**PARTS & SERVICE
NEWS**

REF NO.	AT03145
DATE	Aug. 1, 2003

SUBJECT: MODIFICATION PROCEDURE OF RETARDER CONTROLLER ON HD465-7, HD605-7

PURPOSE: To introduce modification procedure for the retarder controller on HD465-7 and HD605-7 dump trucks
(Retarder controller replacement procedure)

3-1. Modification of the retarder controller

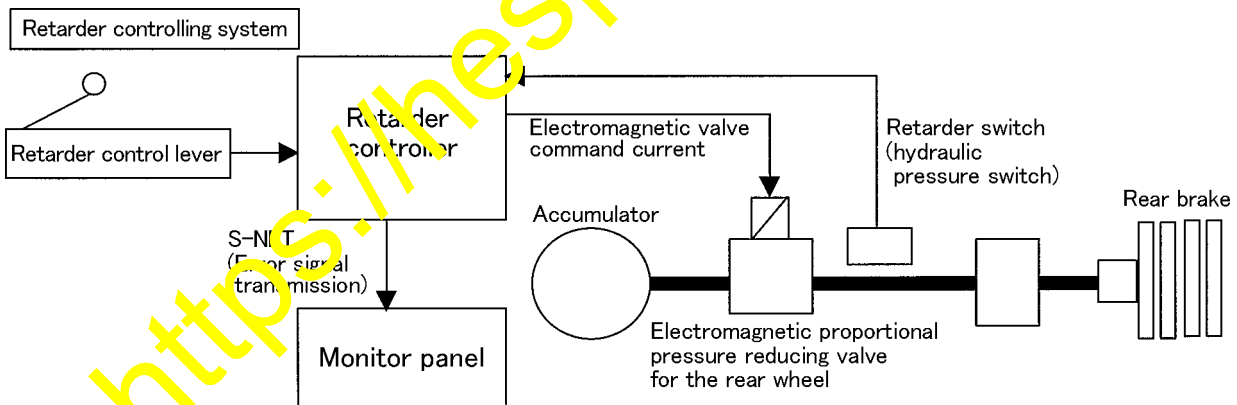
Changing the failure determination condition for the "Failure Code DX11MA and DX11K4" and changing the reaction of the controller

The time required to determine the failure state has been changed so that erroneous failure state may not be detected.

The reaction of the controller after a failure is detected has been changed so that the retarder may start proper operation when the failure state has been repaired. (However, the controller will continue issuance of the failure code even after the failure state has been repaired if the starting switch key is not turned OFF.)

Content of the change	New state	Current state
1. The time required to determine the failure state	3 sec.	1 sec.
2. Reaction of the controller	Will continue outputting. (Command current will be output continuously.)	Will cancel (cut out) outputting. (Command current will be cancelled.)

Fig. 1

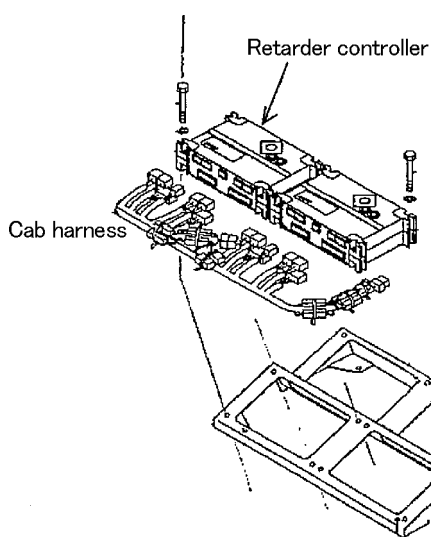
- (1) Open the cover of the controller box being positioned in the rear section in the inside of the operator's cab and disconnect all the connectors being connected to the retarder controller.

- (2) Remove the mounting bolts (4 pcs.) for the retarder controller and remove the controller. (Refer to Fig. 1.)

- (4) Install the replacing new controller (7818-65-4003 in case of the HD465-7 and HD605-7) to the vehicle body by use of the mounting bolts.
 - ☆ Tightening torque for the controller mounting bolts:

2.8 - 3.5 kgmf (27.5 - 34.3 Nm)
- (5) Reconnect the disconnected connectors back to their original places.
At this time, check and confirm the number indicated on the connector tag being attached to the harness and the connecting positions.
(Refer to Fig. 2.)

Fig. 2

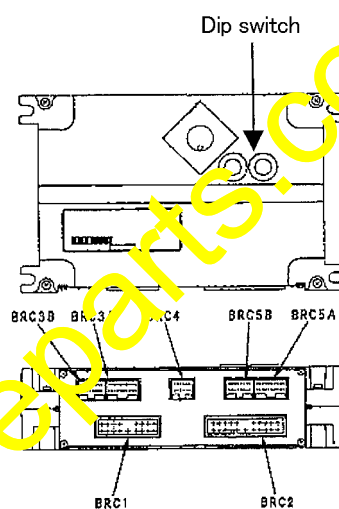
Disconnecting connector numbers are: BRC1, BRC2, BRC3A, BRC3B, BRC4, BRC5A and BRC5B, at 7 places.
